**3 ROTHWELL STREET NW1 8YH
HERITAGE STATEMENT
PLANNING AND LISTED BUILDING CONSENT ISSUE
May 2022**

I.Ø - Introduction

8 .0 Pre-Application Advice Responses

Reference number: 2020/1389/NEW

'As Existing' Drawing from application N° 2003/1942L showing no stair present

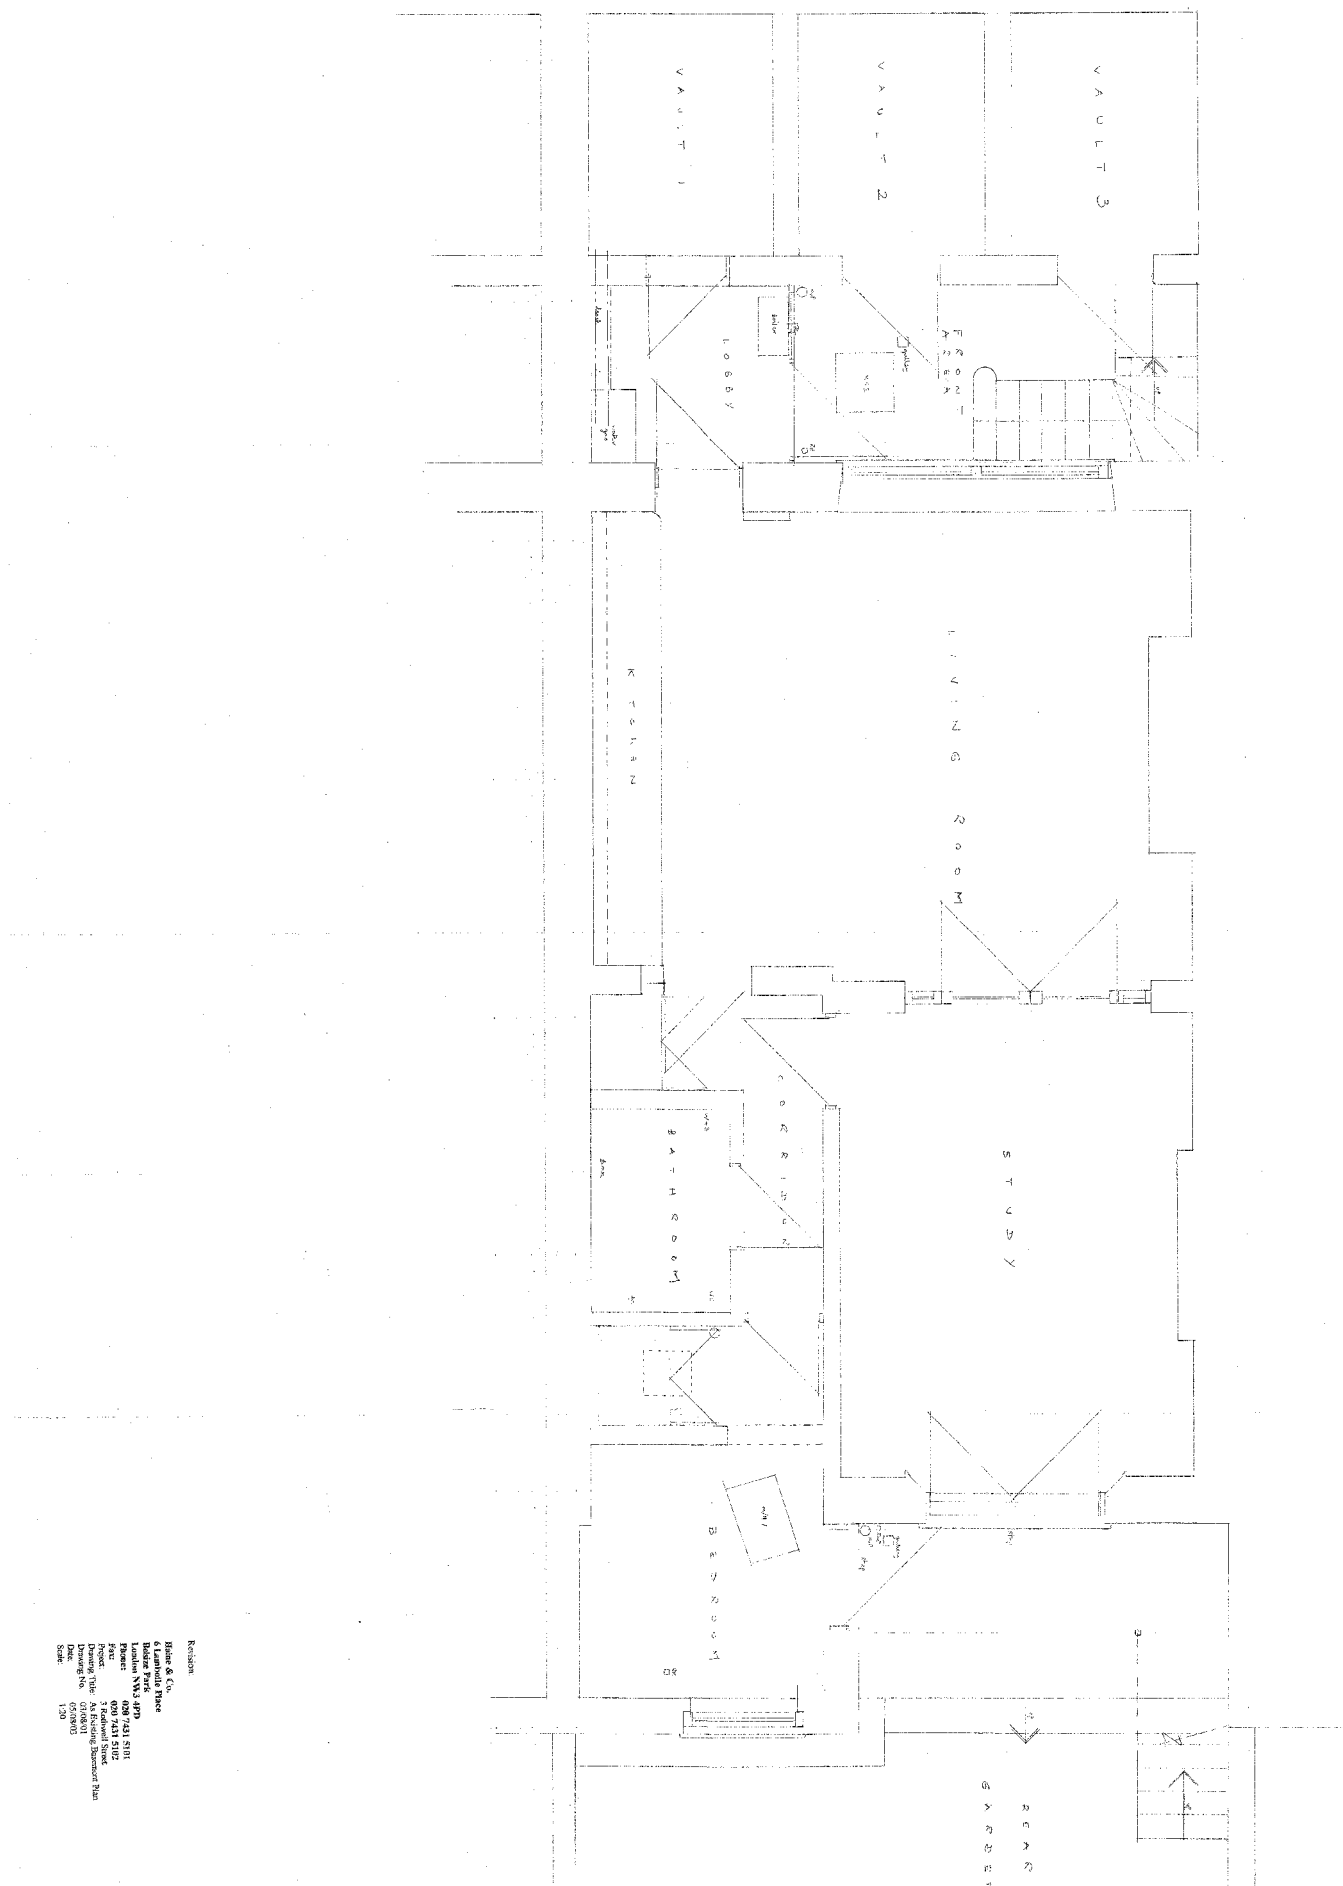
"It is proposed to remove the existing basement to upper-ground floor staircase with a new traditional-styled staircase with a panelled side. The case is made that the existing staircase is non-original and of a modern design. However, it is not clear from the submitted photographs as to its age, which show the staircase covered in large part by a carpet and enclosed by modern partitioning. It appears from the photos that some components of the staircase are historic, including some of the bannisters and the turned newel post, and if this is the case should be retained in situ. It should be stressed that officers will only allow the replacement of the staircase if it

clearly proven it is not historic."

In 2003, Listed Building consent was sought to reinstate a stair to the basement, refer to Application No 2003/1942L. The "as existing" plans submitted as part of the application show no stair in this location. Please see Appendix 1 for copies of the drawings.

9.2 APPENDIX 2 - Works to Basement Vaults: Method Statement Drawing

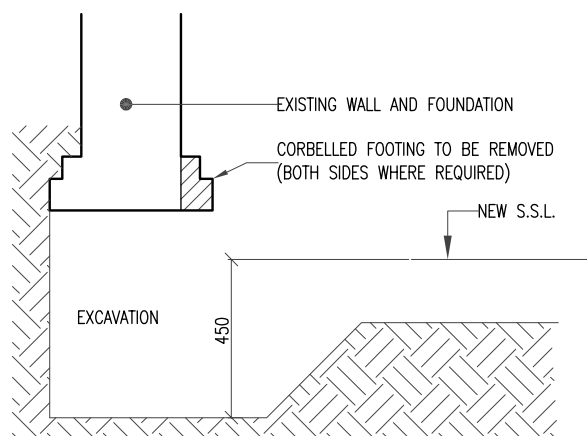
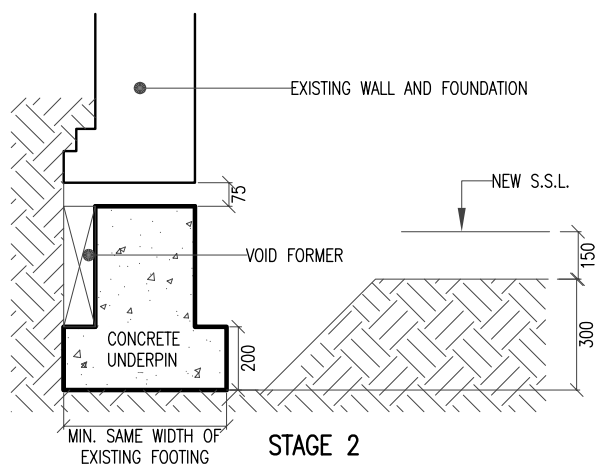
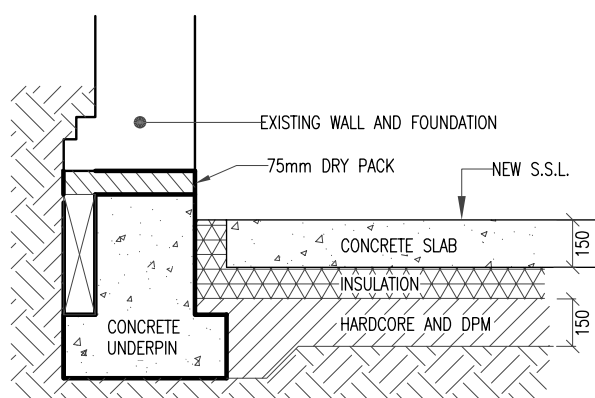
"At the front of the property, the restoration and damp-proofing of the three vaults is welcomed, on the basis that conservation-led techniques are employed, which will require the submission of method statements and schedules of repair works at the application stage. It is stated in the submission that it is intended to reduce the level of the vaults, presumably to provide sufficient head height for a WC/bathroom. As no sections have been provided, it is not clear by how much it will be necessary to lower the floor and how the steps will work both in listed building terms and in accordance with current Building Regulations. It is likely, dependent on the existing arrangement, that the Council will not allow a reduction in level of any more than 300mm and this will depend on the existing floor construction and finishes of being of no historic value. As such, the feasibility of installing a bathroom in the westernmost vault is going to be dependent on the acceptability of lowering the floor. It will also be necessary to demonstrate that the services from any new sanitary appliances can be discreetly integrated into the existing building. It is considered acceptable to construct a cupboard in the lobby area to house services and meters which would otherwise clutter the upper-ground floor entrance hall."

In 2003, Listed Building consent was sought to replace the entire basement floor (including the western vault) with a new concrete slab, refer to Application No 2003/1942L, this also includes details regarding internal tanking to the vault walls and ceiling. This work was carried out as can be seen from the photos of this area. Following these works no historic fabric remains that would be affected by lowering the floor of the vault. Therefore in order for the vault to be a usable space, it is proposed to lower the slab by maximum 450mm in order to achieve a minimum ceiling height of 1.8m at the lowest point of the vault. New drainage and services will be proposed in order to allow installation of sanitary facilities in the future. As requested, please refer to Appendix 2 for method statements and schedules of repair works associated with the vault.
